300 CHASE PARK SOUTH • SUITE 200 • HOOVER, ALABAMA 35244  
205-988-9112

**ADDENDUM NO. 4**  
**NEW SOFTBALL COMPLEX FOR TRUSSVILLE CITY SCHOOLS**  
**Architect Job No. 23-72**  
**April 9, 2024**  
**DCM # Pending**

JOB NO. 23-72
SHEET NO. C0.1

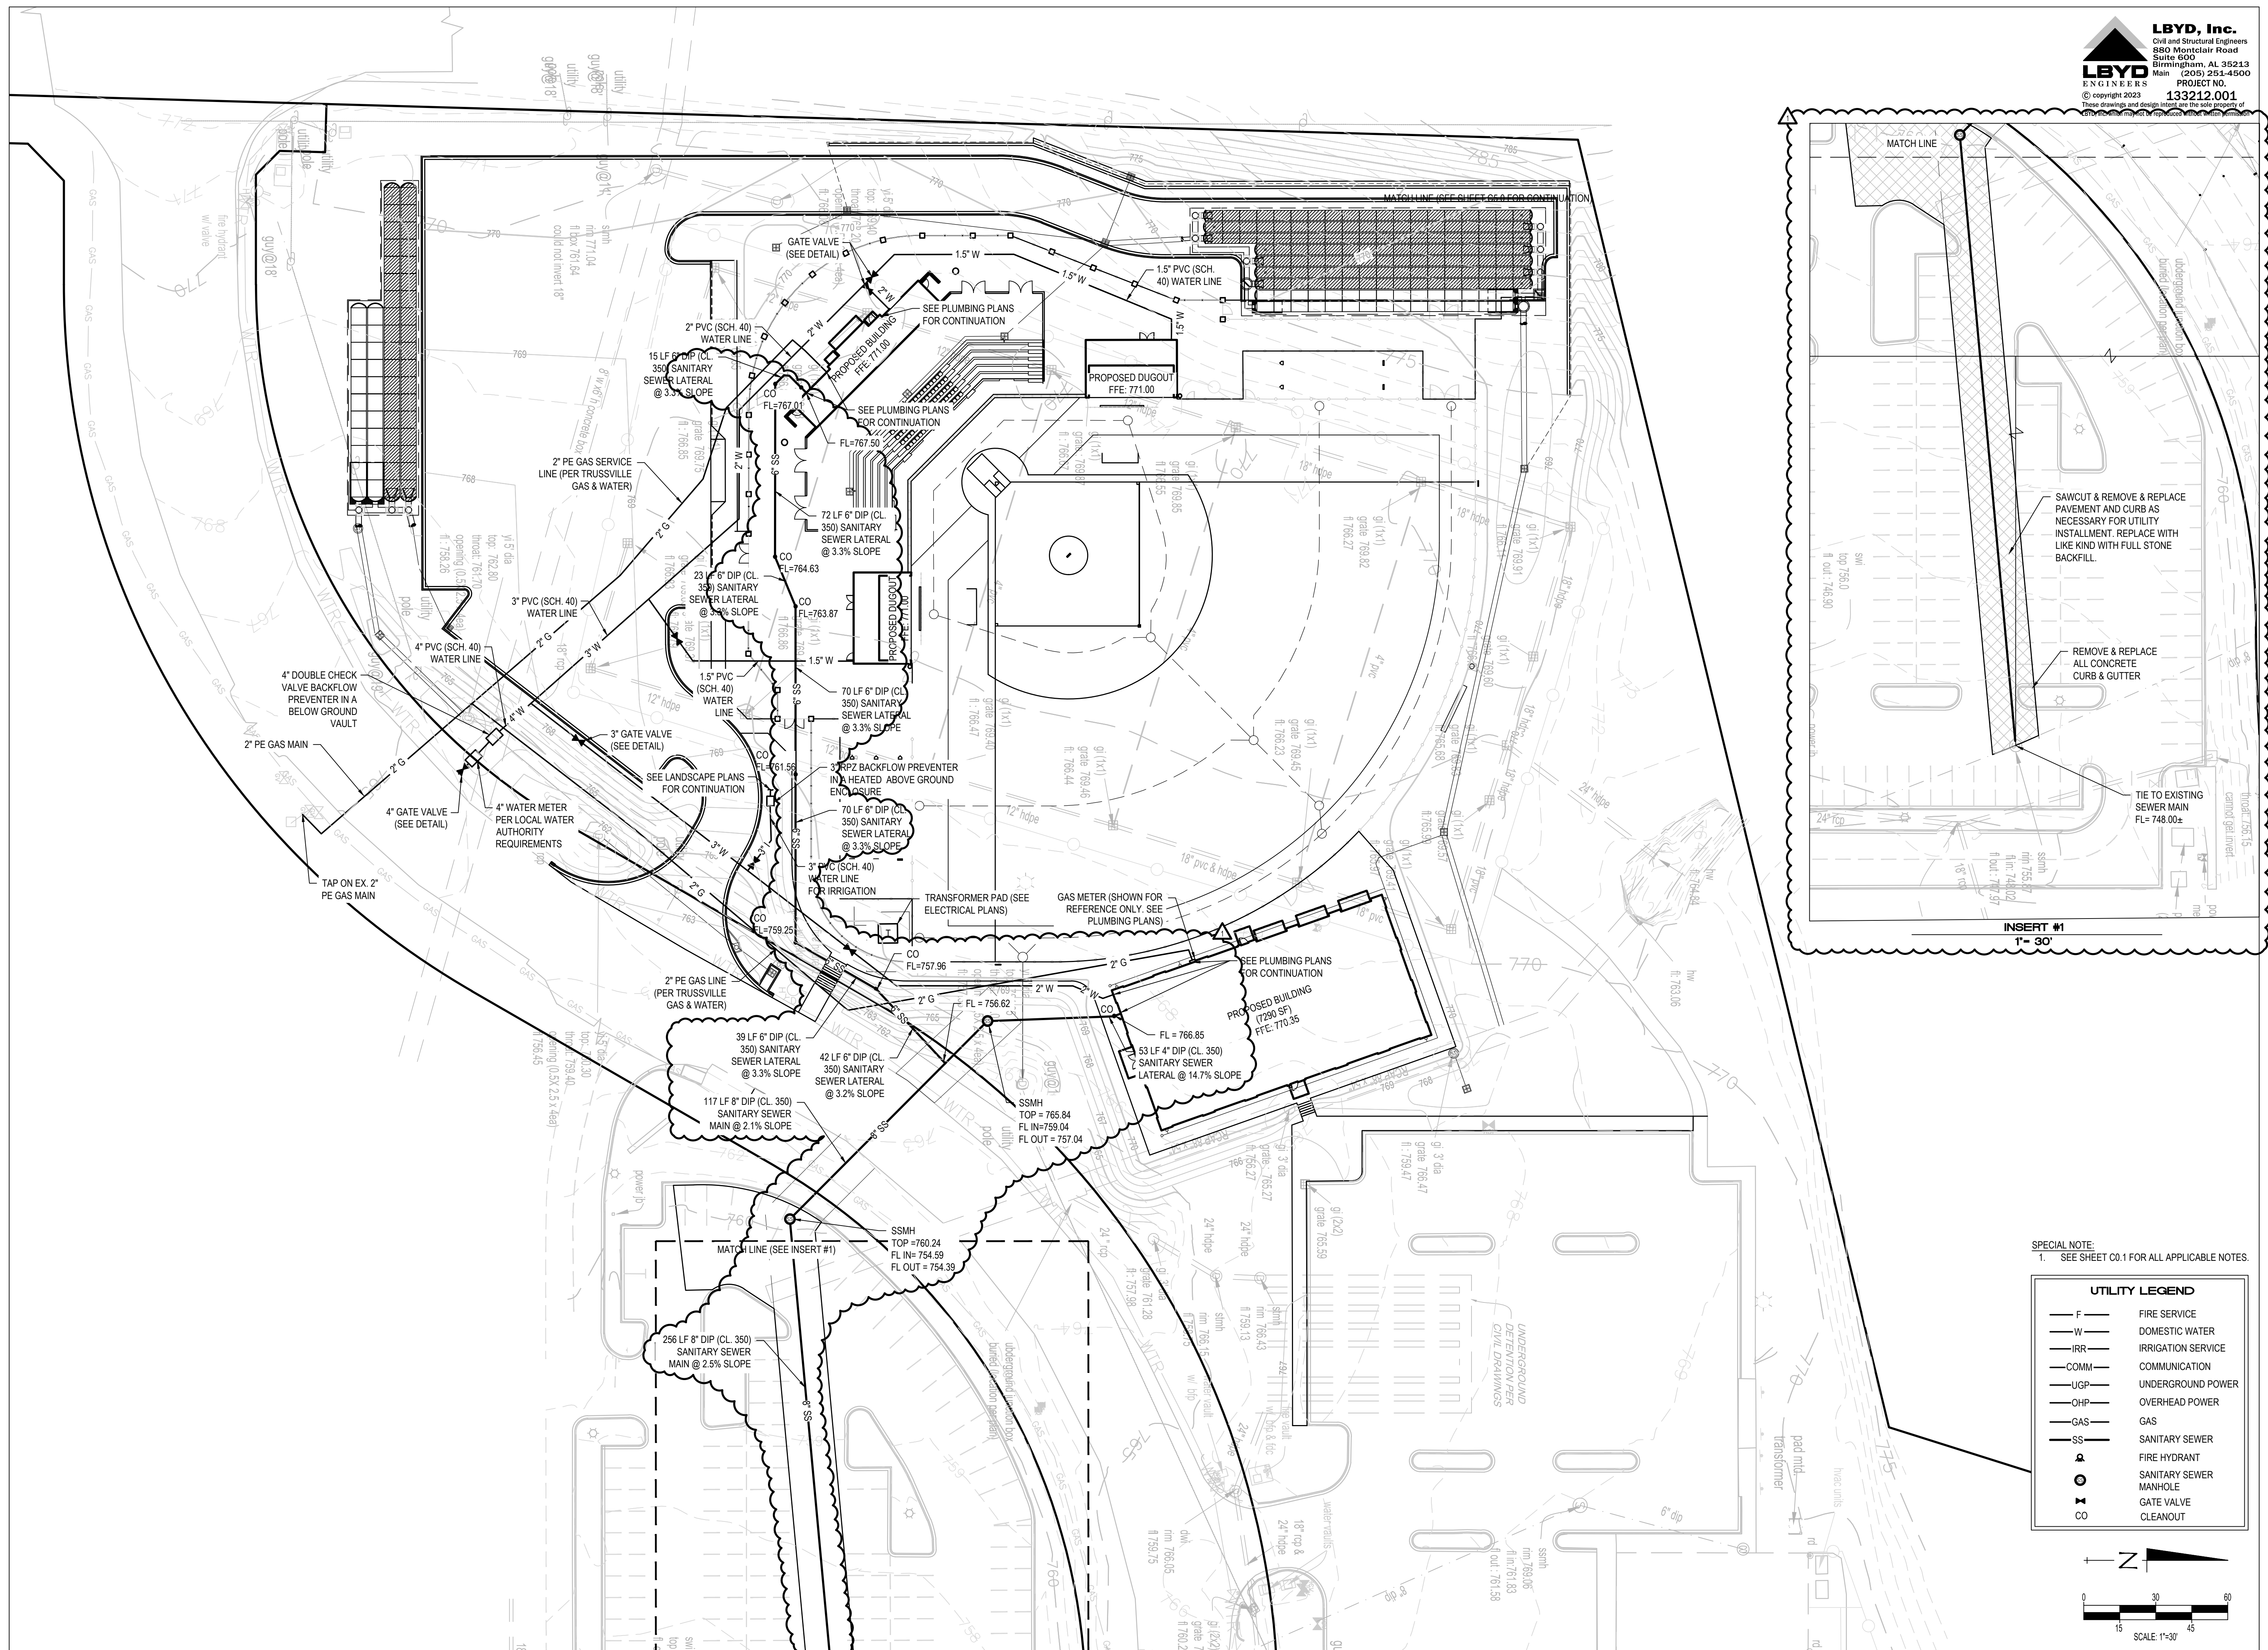
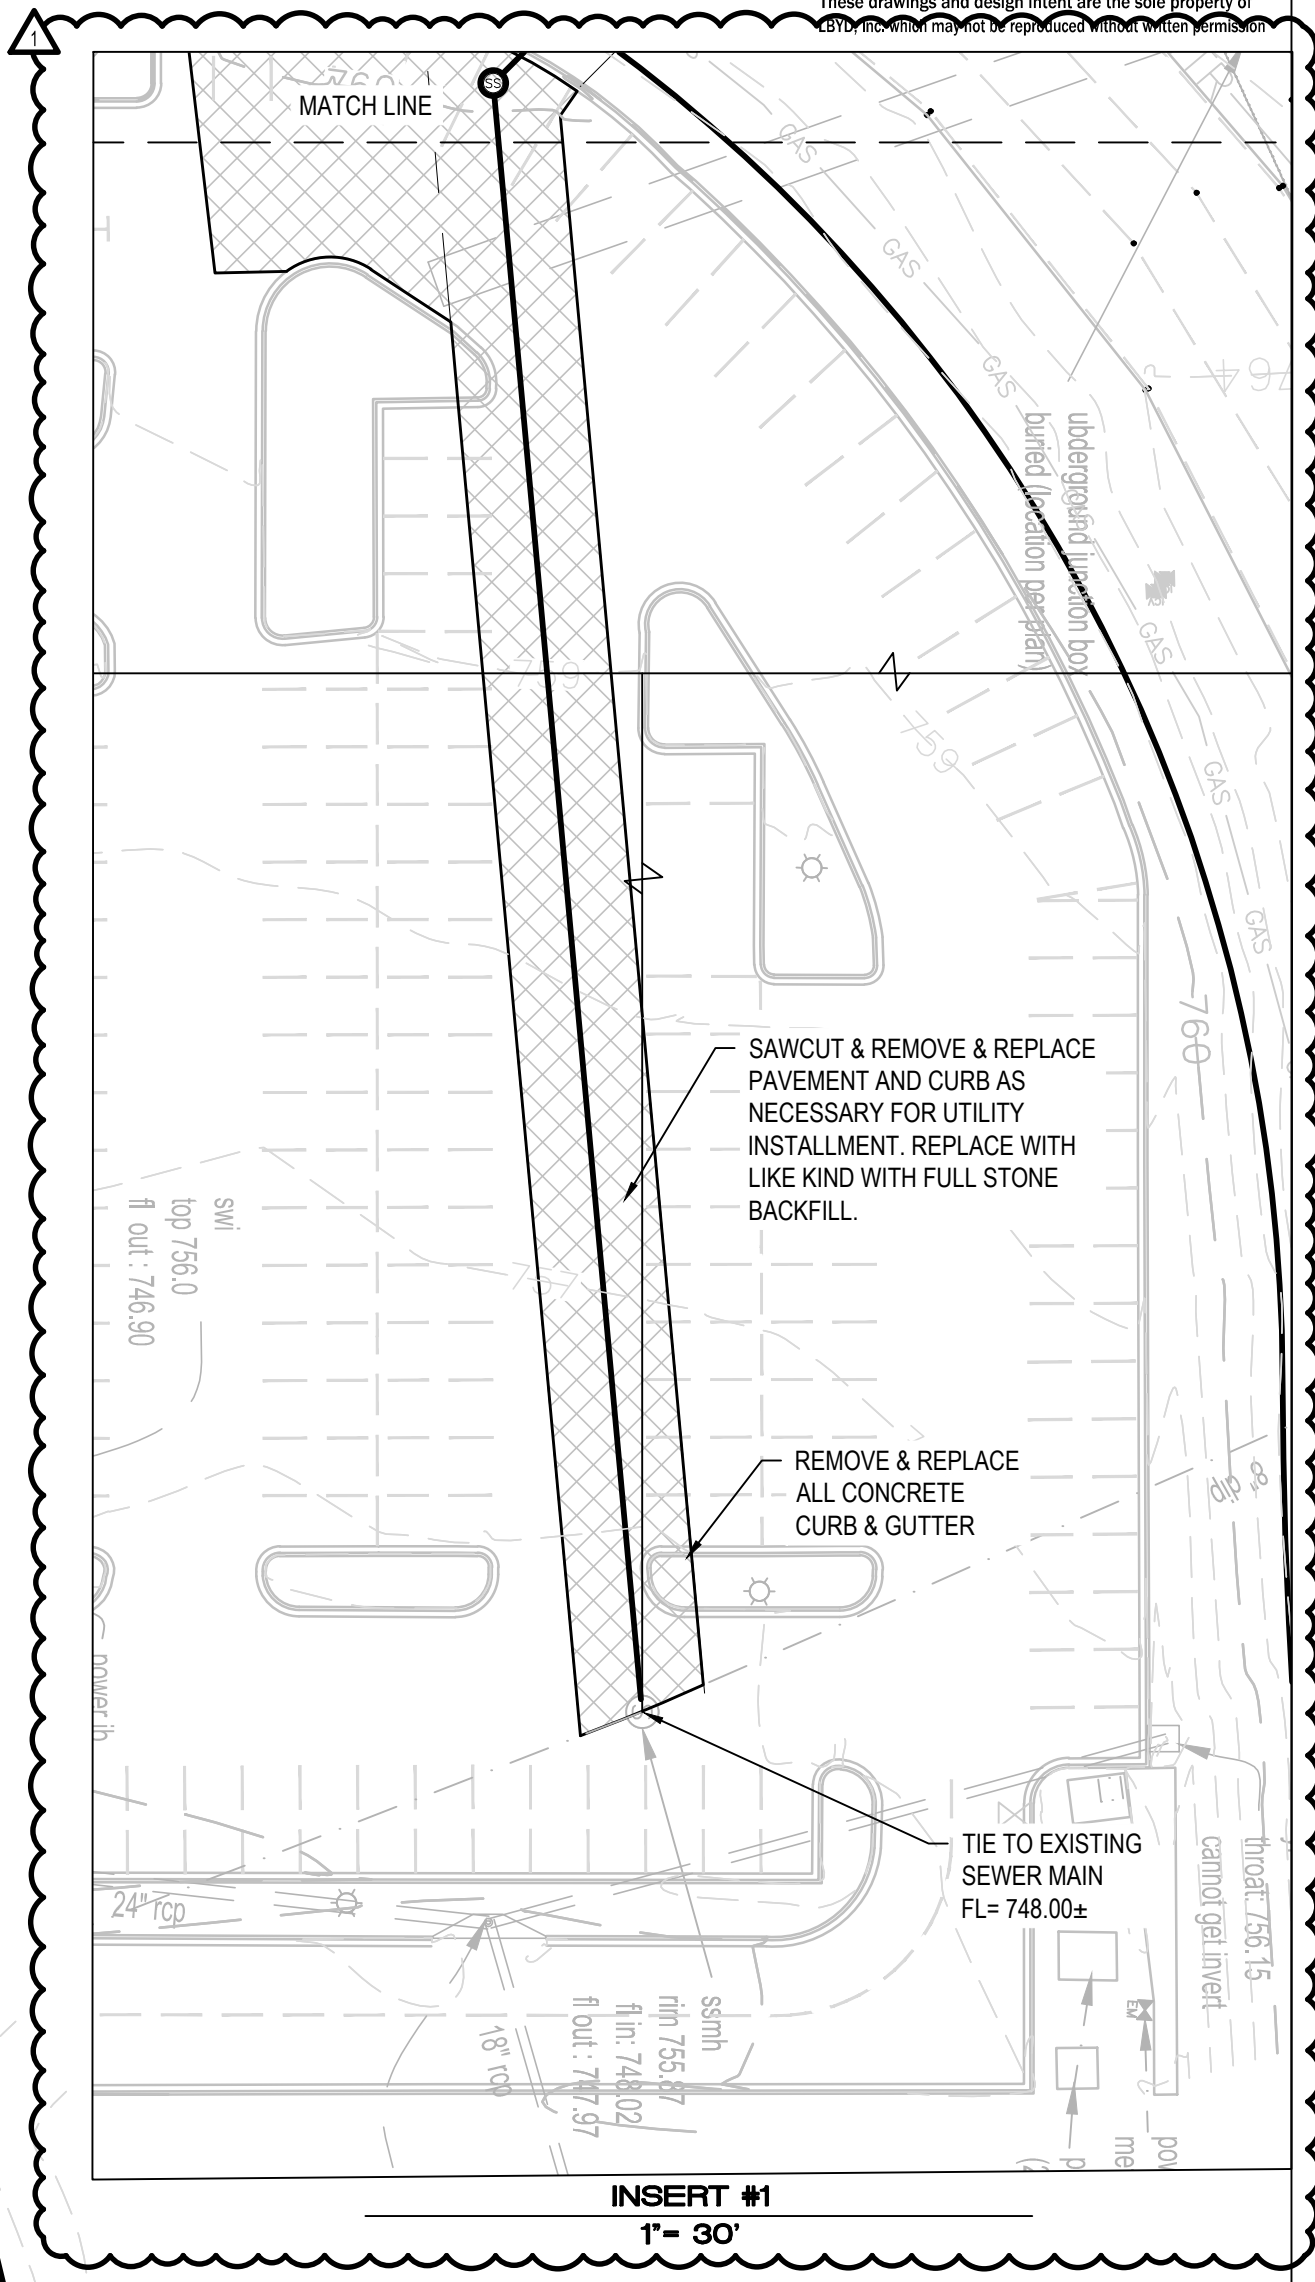
1. See the attached **C0.1** – CIVIL NOTES revised General Notes to **ADD**:

“11. GENERAL CONTRACTOR IS RESPONSIBLE FOR OBTAINING ADEM PERMIT PRIOR TO START OF CONSTRUCTION. CONSTRUCTION SITE IS WITHIN ADEM PRIORITY WATERSHED. FULL CBMPP PLAN WILL BE REQUIRED BY THE CONTRACTOR. 3 PHASE EROSION CONTROL PLANS ARE INCLUDING HERIN; CONTRACTOR SHALL REFERENCE BMP'S NECESSARY TO MEET ALL PERMIT REQUIREMENTS.”
2. See the attached **C5.0** – SITE UTILITY PLAN revised to **ADD “REMOVE & REPLACE ALL CONCRETE CURB & GUTTER.”**
3. See the attached **REVISED C5.1** – **JCES PLAN & PROFILE.**
4. See attached Sheet **P1.2** – PLUMBING – HIT HOUSE FLOOR PLANS for revisions to 4 Pressure – Enlarged – HIT House Lower Level.
5. See attached Sheet **M0.3** – MECHANICAL – SCHEDULES for revisions to ERU-1 Schedule.

11. GENERAL CONTRACTOR IS RESPONSIBLE FOR OBTAINING ADEM PERMIT PRIOR TO START OF CONSTRUCTION. CONSTRUCTION SITE IS WITHIN ADEM PRIORITY WATERSHED. FULL CBMP PLAN WILL BE REQUIRED BY THE CONTRACTOR. 3 PHASE EROSION CONTROL PLANS ARE INCLUDING HEREIN; CONTRACTOR SHALL REFERENCE BMP'S NECESSARY TO MEET ALL PERMIT REQUIREMENTS.
